1-3 Sudborough Road Slipton

Further to my report of 18th October 2018 on the initial clearance and support work for the property following the fire I would confirm that I have re-inspected specifically to comment on the amount of masonry to be rebuilt on the rear elevation. An extract showing this area is copied below.

Photograph No.1

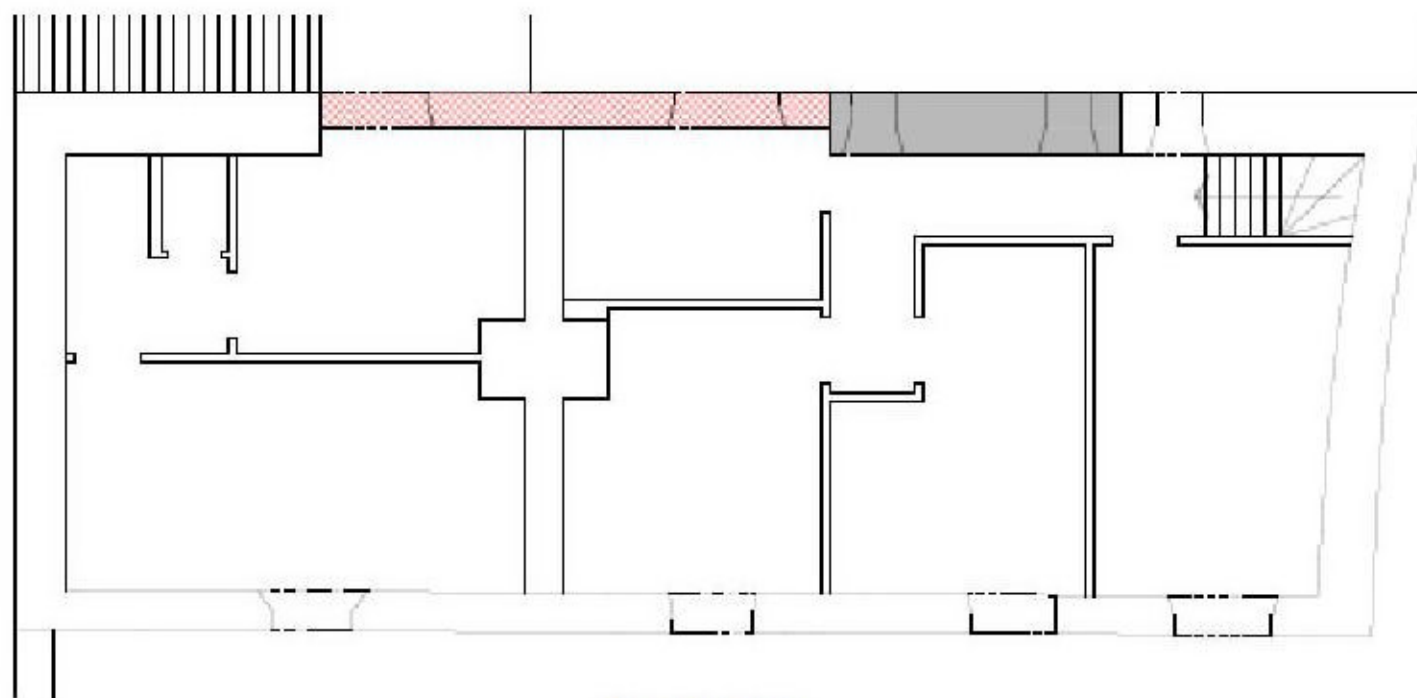
Now the debris has been removed the wall could be inspected in detail and it is evident that from the current line where it has been taken down that this should include an additional 1m which takes it past the external buttress as can be seen on photograph No.1. The masonry on this section, apart from being significantly out of true is in a poor condition as noted when viewing the end exposed section as can be identified on photograph No.2.

First Floor Plan

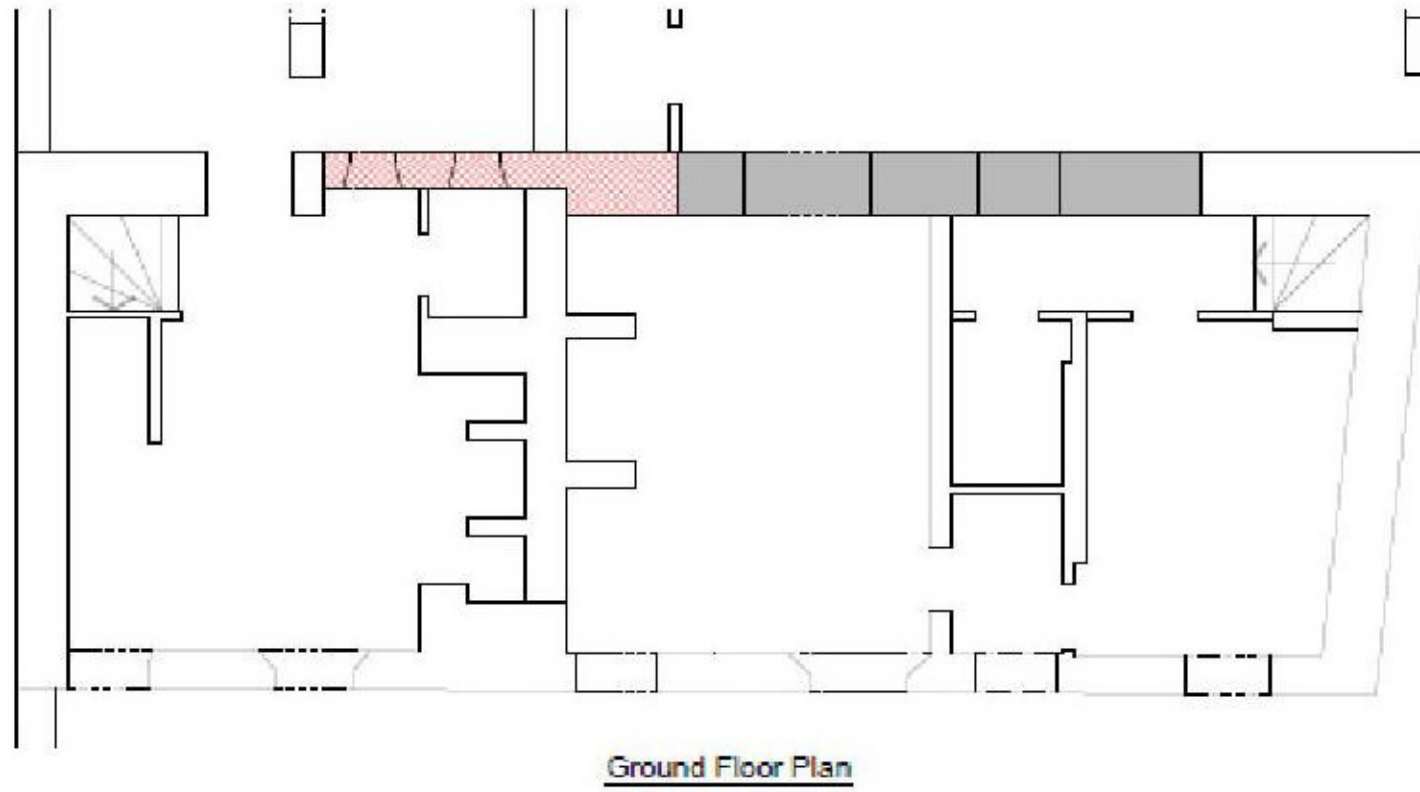
Based on your proposed scheme shown on drawing 1341-02-11 and also on the demolition drawing 1341-02-10 then the amount of the existing masonry that can be retained can be increased as shown on the diagram below. The red hatch shows the areas to be rebuilt which includes that already removed and then the grey shaded section is the area previously shown as being taken down but we recommend can remain. It is appreciated that for the scheme to be viable that the first floor when rebuilt, should be 450mm wide so as to provide room for the bathroom and this is acceptable from a structural point of view. As the inner skin of the wall will now partly off the hearting then this also means that it is important for this to be grouted.
